ACE/ATRIUM-10 Critical Power Correlation

ANP-10249NP-A
Revision 2

SUBJECT: FINAL SAFETY EVALUATION BY THE OFFICE OF NUCLEAR REACTOR
REGULATION TOPICAL REPORT ANP-10249PA, REVISION 1,
SUPPLEMENT 1P, REVISION 0, "IMPROVED K-FACTOR MODEL FOR
ACE/ATRIUM-10 CRITICAL POWER CORRELATION" (TAC NO. ME7964)

**Response to a Request for Additional Information Regarding ANP-10249P Revision 0,
"ACE/ATRIUM-10 Critical Power Correlation"**

Figure 2.1. 3D Boiling Map

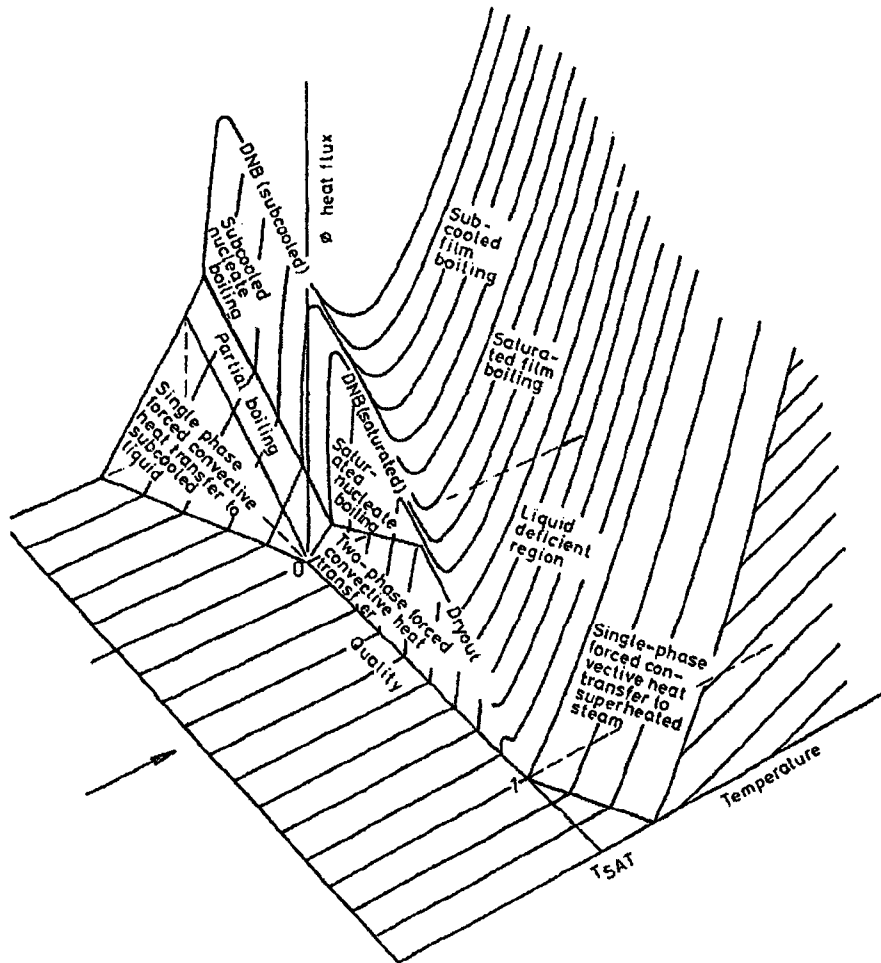
Response 2:

The [] provides a complete and adequate representation of BWR dryout. The justification for this conclusion is provided below.

The mechanism for critical heat flux implied in the question is known as DNB (Departure from Nucleate Boiling), a phenomenon known to occur in PWR's (Pressurized Water Reactors). In BWR's (Boiling Water Reactors), the mechanism for critical heat flux is dryout or disappearance of the annular liquid film. The request by the staff can be answered by addressing the following question: "What conditions are required to achieve DNB?"

Next, consider the 3D boiling map associated with convective boiling in a vertical heated channel Figure 2.1. This figure portrays the heat flux in terms of the quality and surface temperature. The surface is divided into regions according to the mechanism of heat transfer. Critical heat flux corresponds to the peak in the three dimensional surface at qualities less than 1.0 and temperatures slightly above the saturation temperature. The critical heat flux peak is divided into three parts – critical heat flux associated with subcooled DNB, critical heat flux associated with saturated DNB, and critical heat flux associated with annular flow dryout. It is observed that dryout occurs at higher qualities and DNB occurs at lower qualities and with subcooled boiling. Thus, the question "What conditions are required to achieve DNB?" can be answered by [

Figure 16.1. Boiling Regime Map

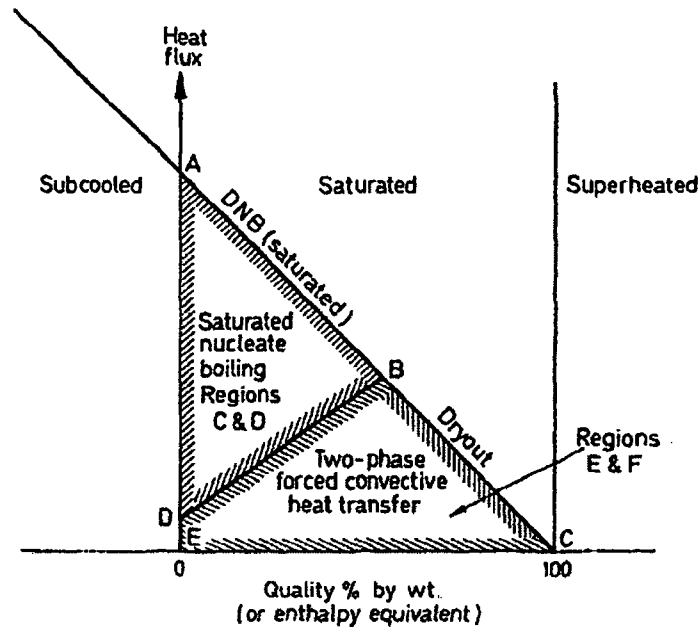
Response 16:

The load rejection and loss of flow events are the most challenging CPR events in a BWR and these events are therefore the principal CPR limiting events simulated in testing. The character of depressurization events will be discussed from the perspective of [

Consider first the boiling heat transfer and flow regime in relation to critical heat flux, Figure 16.1. This figure provides a map of boiling regime as a function of quality and shows the critical heat flux boundary. For a given state, a decrease in pressure increases the quality. Thus, for a constant heat flux, the state point moves to the right in Figure 16.1. Increasing the quality and moving to the right in Figure 16.1 leads away from nucleate boiling¹ and towards two phase forced convection heat transfer (annular flow regime). The heat transfer is so efficient that it is not possible to achieve the superheat at the rod surface necessary for nucleation.

¹ It was already ascertained in the response to QUESTION 2 that, within the range of applicability of the ACE/ATRIUM-10 correlation, it is not possible to achieve DNB. Thus, critical heat flux will occur to the right of point B in Figure 16.1.
